I, REZA AFAGHPUR, NMPE 11814, OF SBS CONSTRUCTION AND ENGINEERING, LLC, HEREBY CERTIFY THAT THIS PROJECT HAS BEEN GRADED AND WILL DRAIN IN SUBSTANTIAL COMPLIANCE WITH AND IN ACCORDANCE WITH THE DESIGN INTENT OF THE APPROVED PLAN DATED 08-04-2013. THE RECORD INFORMATION EDITED ONTO THE ORIGINAL DESIGN DOCUMENT HAS BEEN OBTAINED BY NMPS 9801, OF SBS CONSTRUCTION AND ENGINEERING, LLC. I FURTHER CERTIFY THAT I HAVE PERSONALLY VISITED THE PROJECT SITE ON AND HAVE DETERMINED BY VISUAL INSPECTION THAT THE SURVEY DATA PROVIDED IS REPRESENTATIVE OF ACTUAL SITE CONDITIONS AND IS TRUE AND CORRECT TO THE BEST OF MY KNOWLEDGE AND BELIEF. THIS CERTIFICATION IS SUBMITTED IN SUPPORT OF A REQUEST FOR FINAL CERTIFICATE OF OCCUPANCY.

LOT 26-A, BLOCK J, LAVALAND ADDITION GRADING AND DRAINAGE PLAN

**LOT 26-A, BLOCK J, LAVALAND ADDITION
 SITE PLAN FOR BUILDING PERMIT**

LOT 26-A, BLOCK J, LAVALAND ADDITION
SITE PLAN FOR BUILDING PERMIT

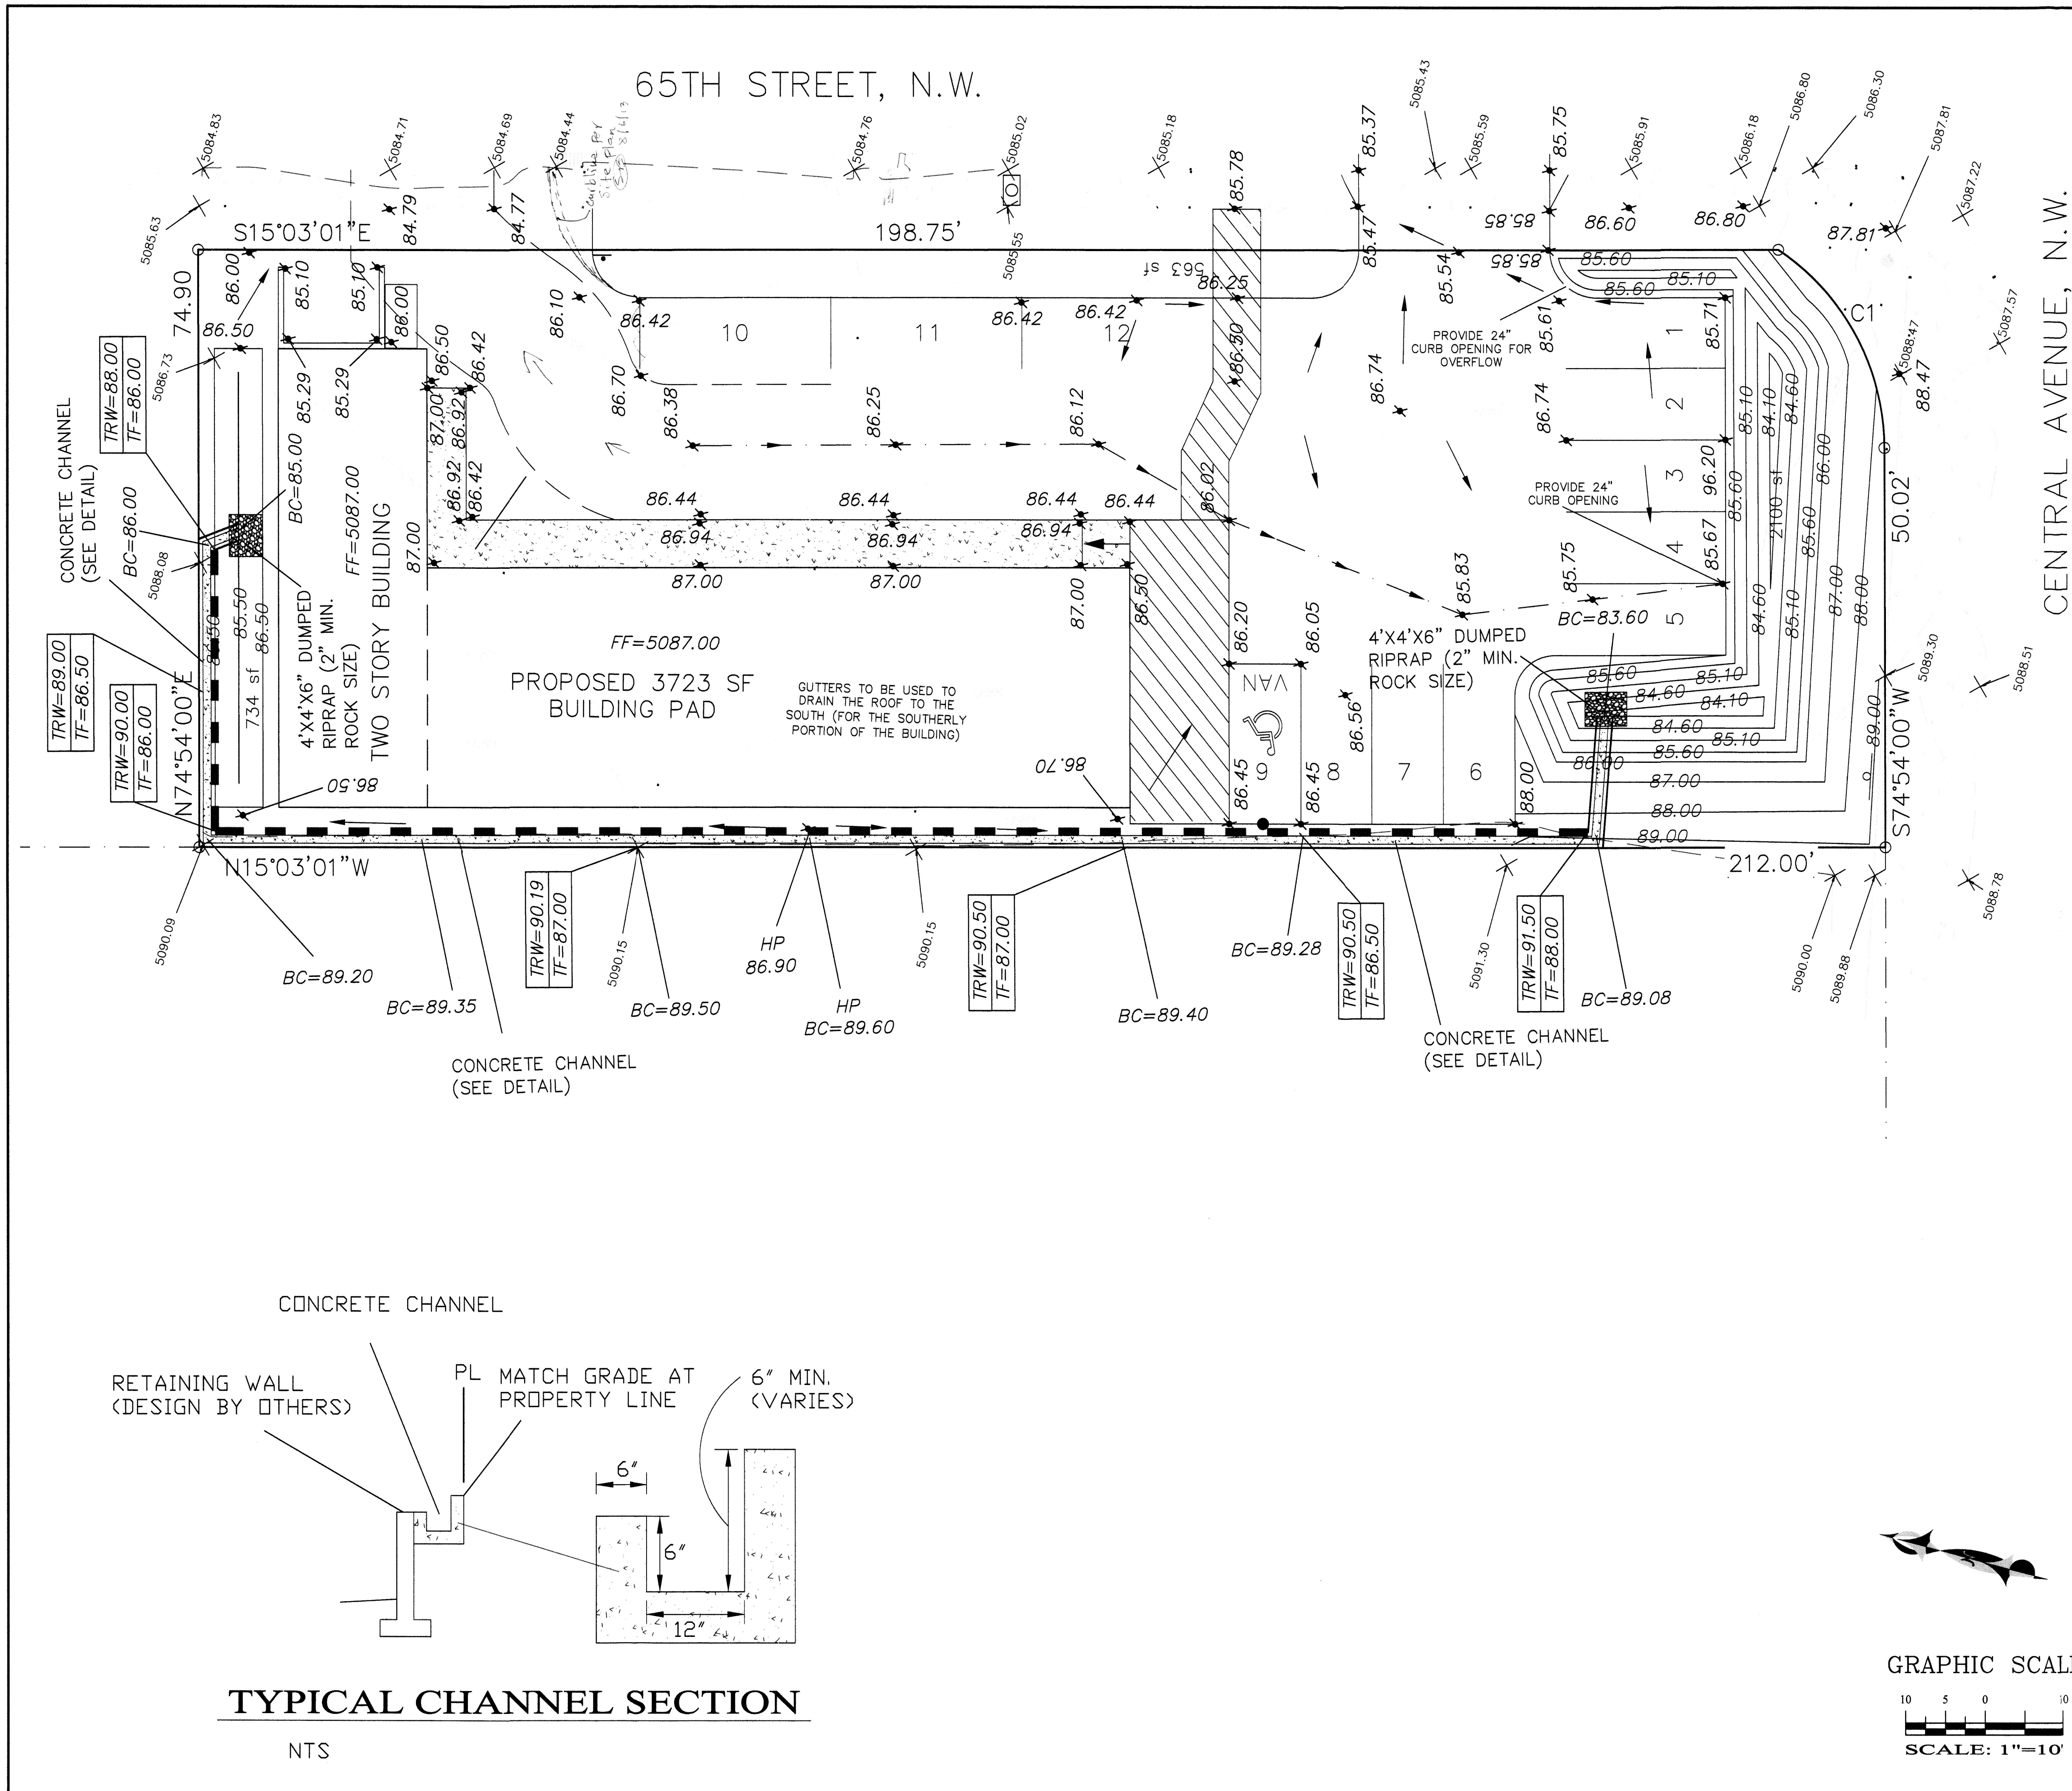
40' driveway
- 13.5' Refuse
- 4.0' Motorcycle Stall
- 20.0' Driveway

TRAFFIC CIRCULATION LAYOUT
APPROVED
[Signature] 4/21/13
Signed Date

LAST REVISION: 06-18-13

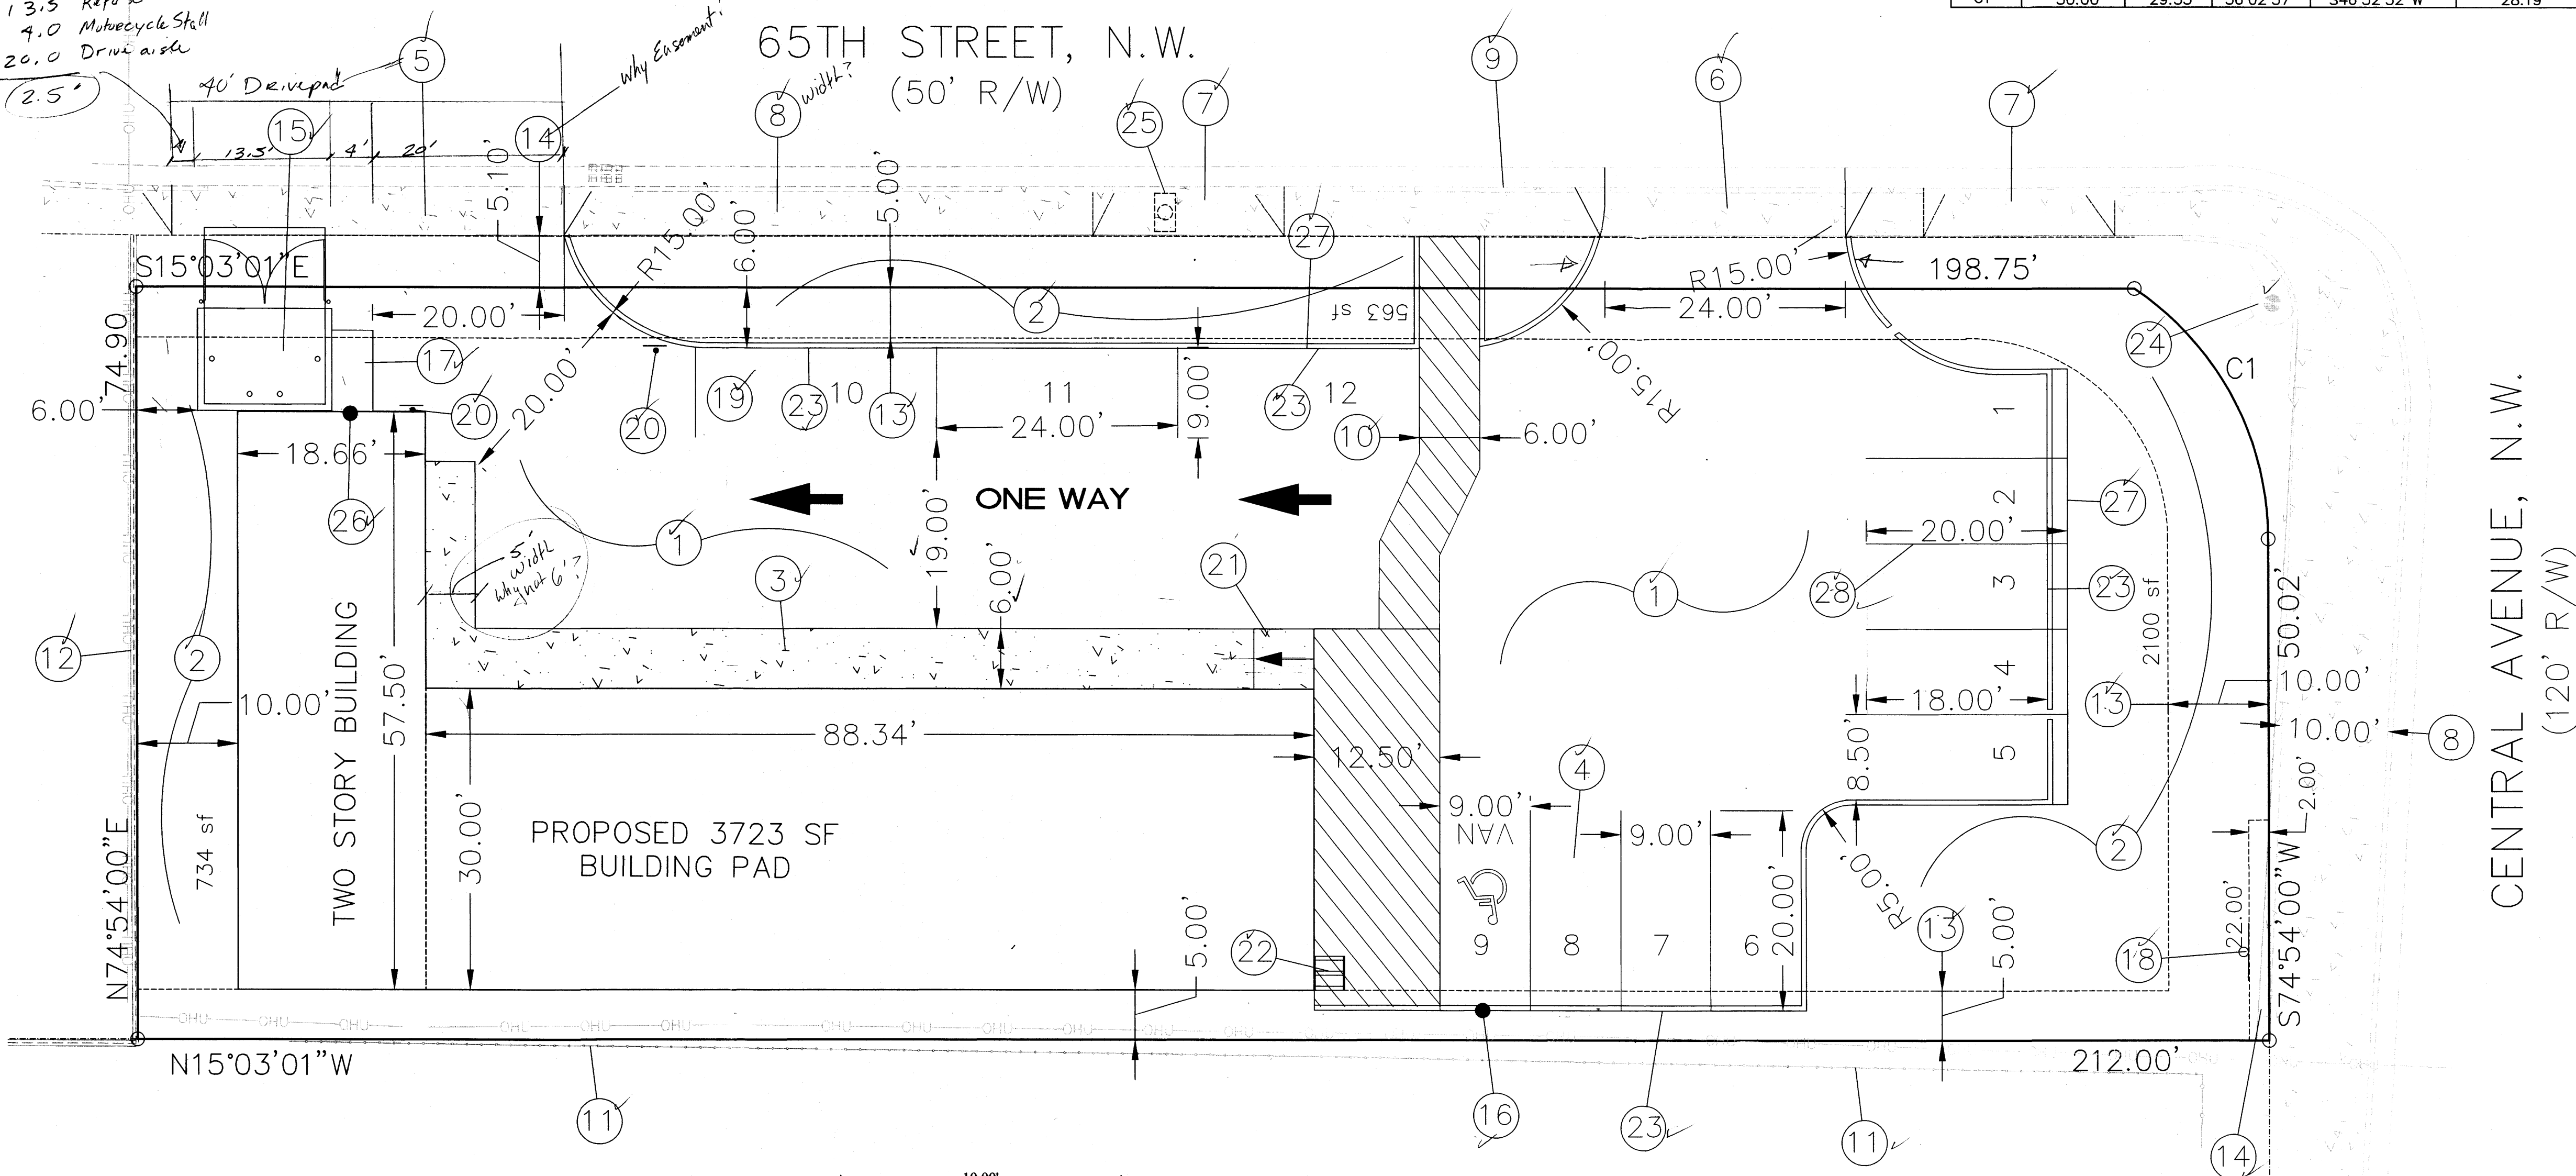
- KEYED NOTES:
- ASPHALT PAVING AREA, TYP. New or Existing?
 - LANDSCAPING AREA.
 - NEW 6' SIDEWALK, 6" ABOVE ASPHALT
 - 9' WIDE X 20' DEEP PARKING SPACES
 - EXISTING 40' WIDE DRIVE PAD

- NEW 24' DRIVEWAY PER COA STD DWG #2425
 - REMOVE EXISTING DRIVEWAY, BUILD C & G AND SIDEWALK PER COA STD DWG. #2415A & 2430
 - EXISTING SIDEWALK WIDTH?

- EXISTING SIDEWALK EASEMENT
 - NEW TRASH ENCLOSURE PER COA STANDARDS
 - HANDICAP SIGN PER COA STANDARDS Not COA, ADA
 - NEW MOTORCYCLE PARKING (4'X8')
 - EXISTING SIGN

- 9' BY 24' PARKING SPACES
 - DO NOT ENTER SIGN
 - WC RAMP PER COA STANDARD & ADA COMPLIANT 1:12 Slope
 - BICYCLE RACK
 - INSTALL PINNED CURB TYP. I, STD DWG # 2415A

LOT 26-A, BLOCK J, LAVALAND ADDITION SITE PLAN FOR BUILDING PERMIT			
DRAWING:	DRAWN BY:	DATE:	SHEET #
201314-SP.DWG	SH-B	05-29-2013	1

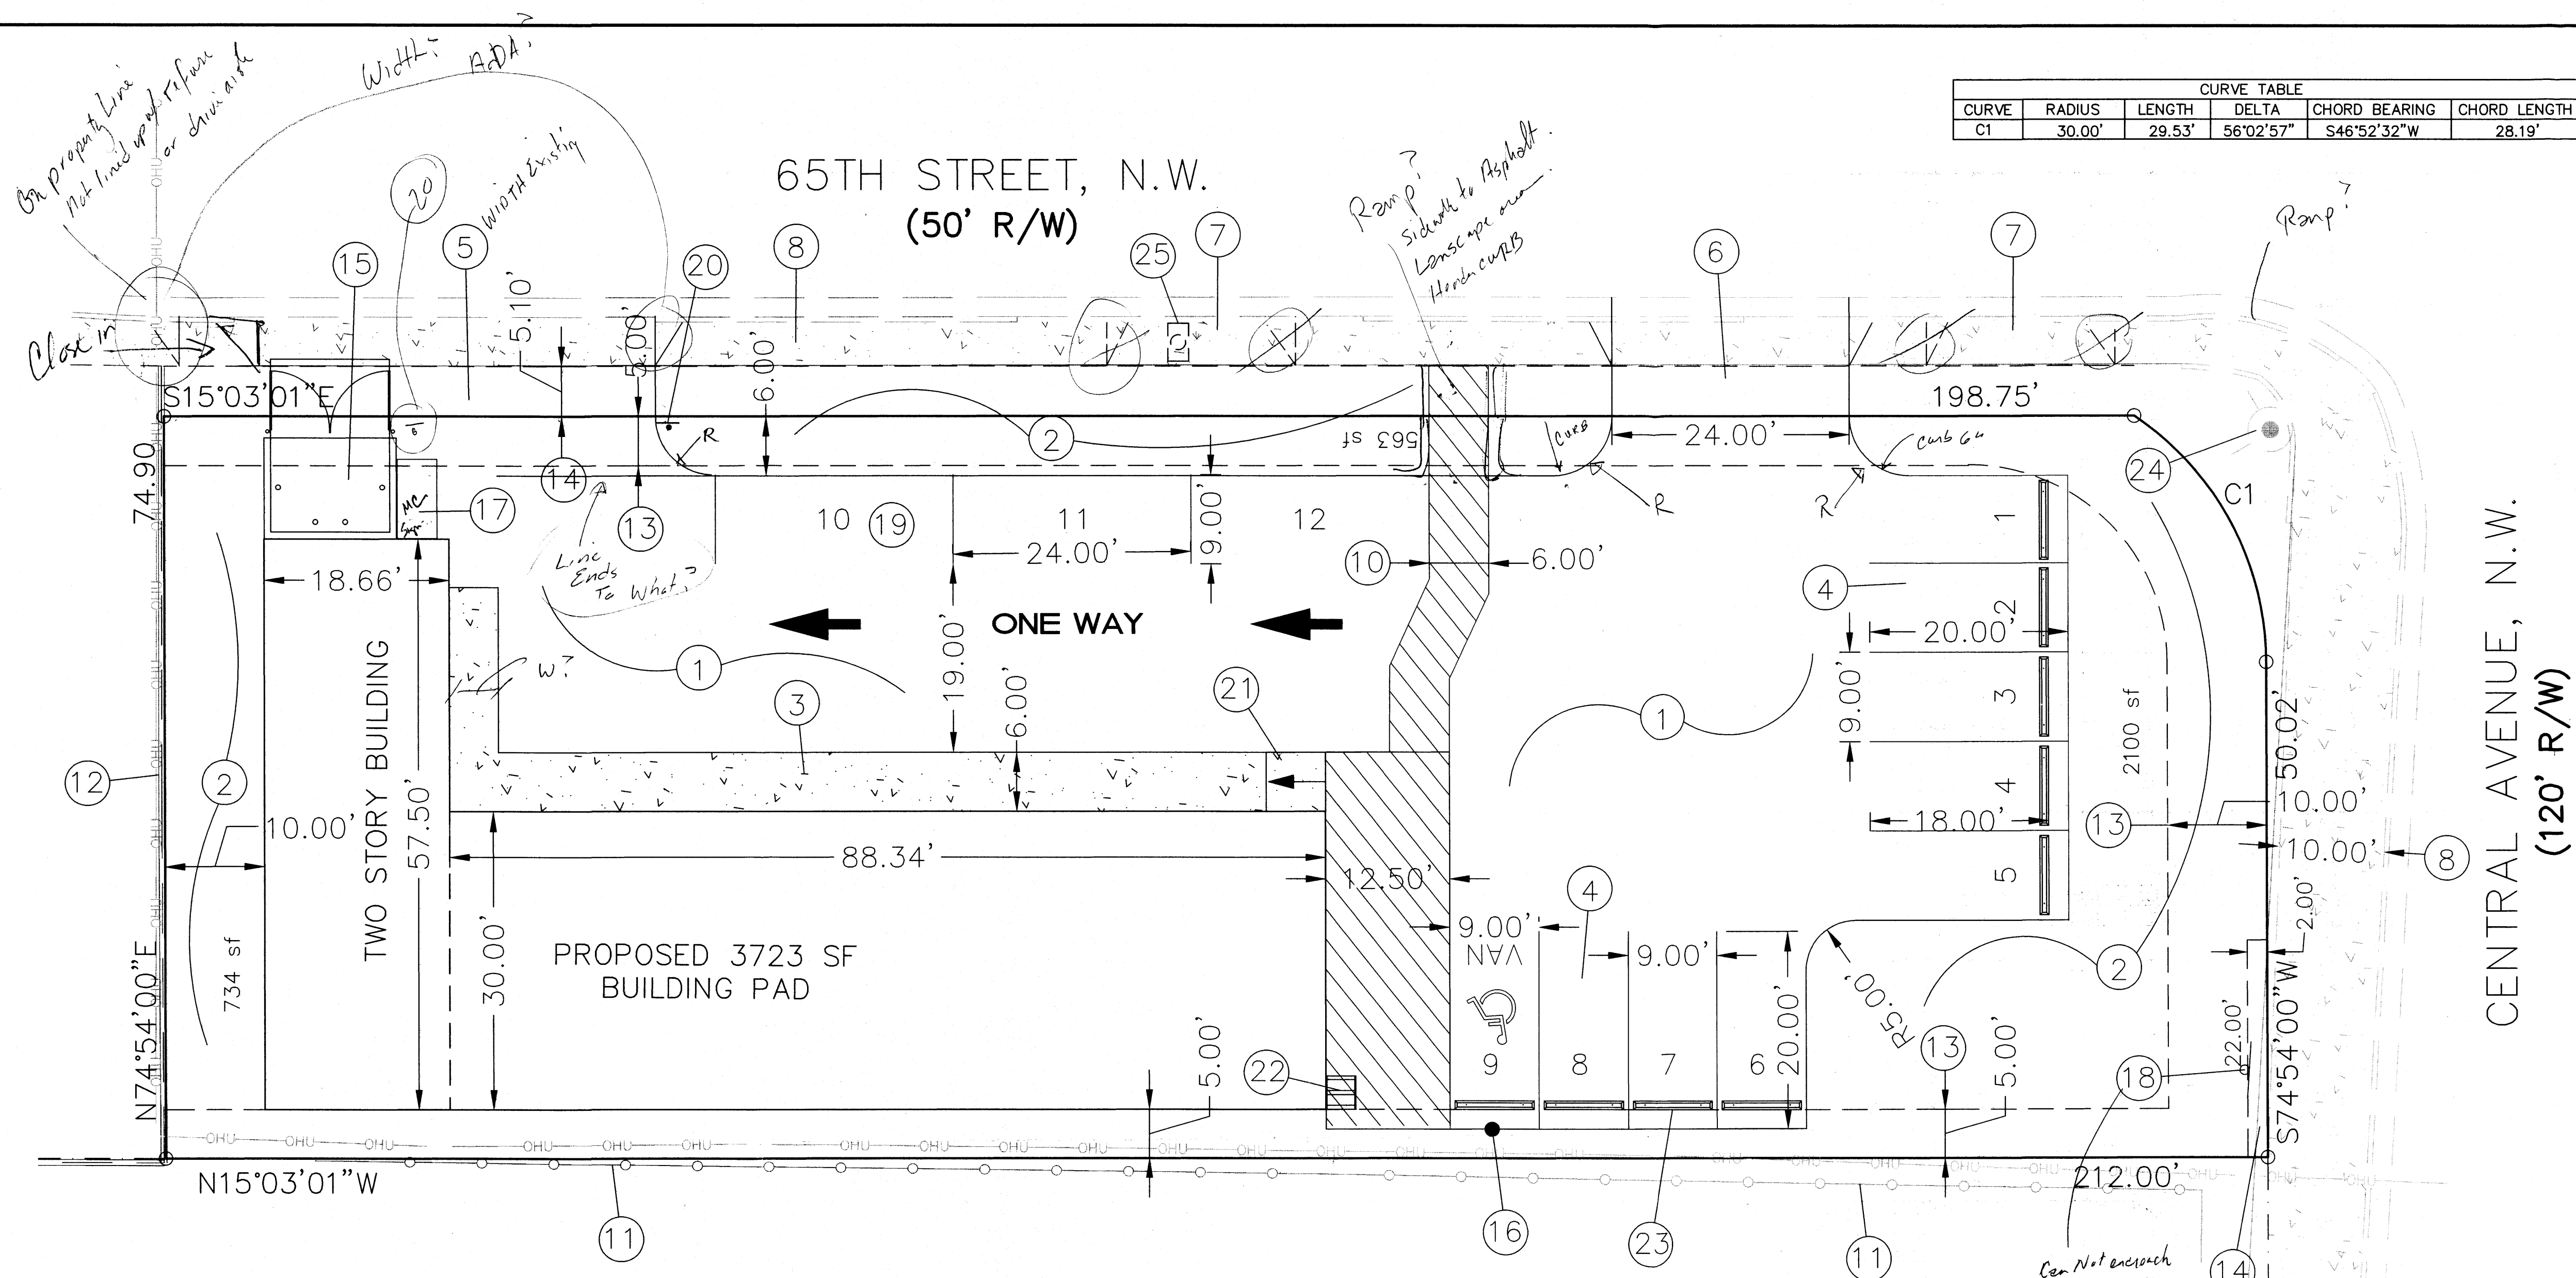
- 1. ASPHALT PAVING AREA, TYP.
- 2. LANDSCAPING AREA. *Sign & Note*
- 3. NEW 6\"/>
- 4. 9\"/>
- 5. EXISTING DRIVE WAY ENTRANCE *W/OTH, ADA?*
- 6. NEW 24\"/>
- 7. REMOVE EXISTING DRIVEWAY, BUILD C & G AND SIDEWALK PER COA STD DWG. #2415A & 2430
- 8. EXISTING SIDEWALK - 10 FT. Wide? *Curbs Gutter?*
- 9. EXISTING STANDARD CURB & GUTTER
- 10. 6\"/>
- 11. EXISTING CHAIN LINK FENCE
- 12. EXISTING BLOCK WALL
- 13. EXISTING PUBLIC UTILITY EASEMENT
- 14. EXISTING SIDEWALK EASEMENT
- 15. NEW TRASH ENCLOSURE PER COA STANDARDS
- 16. HANDICAP SIGN PER COA STANDARDS
- 17. NEW MOTORCYCLE PARKING (4'x8') *Sign Posted.*
- 18. EXISTING SIGN
- 19. 9\"/>
- 20. DO NOT ENTER SIGN
- 21. MC RAMP PER COA STANDARD
- 22. BICYCLE RACK
- 23. INSTALL PRECAST CONCRETE BUMPER, 2\"/>
- 24. EXISTING FIRE HYDRANT
- 25. EXISTING WATER METER BOX
